**Réponses du Transporteur
à la demande de renseignements numéro 1
d'Option consommateurs
(« OC »)**

DEMANDE DE RENSEIGNEMENTS N° 1 D'OPTION CONSOMMATEURS (OC) À HQT

DEMANDE DU TRANSPORTEUR DE MODIFICATION DES TARIFS ET CONDITIONS DES
SERVICES DE TRANSPORT POUR LES ANNÉES 2021 ET 2022

R-4167-2021

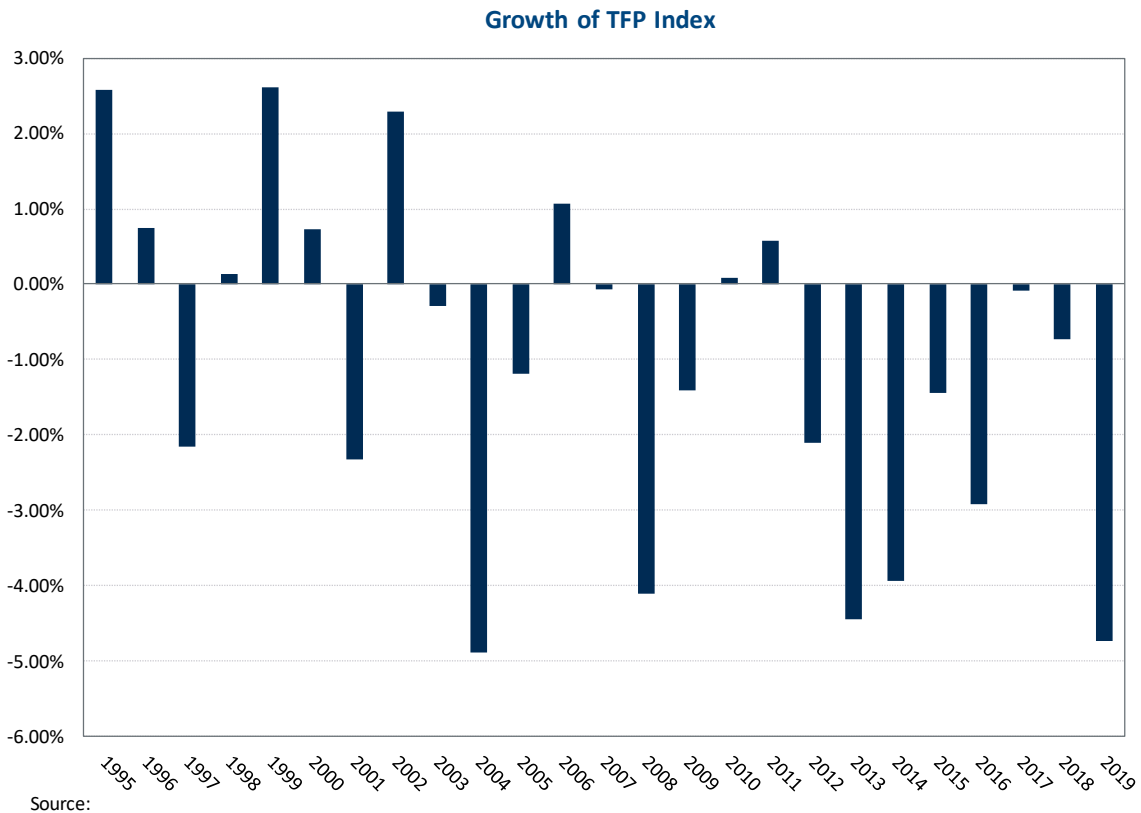
2.4 Please Graph the US Transmission Industry TFP growth over the sample Period based on the Brattle Model.

4 **Please see graphic below.**
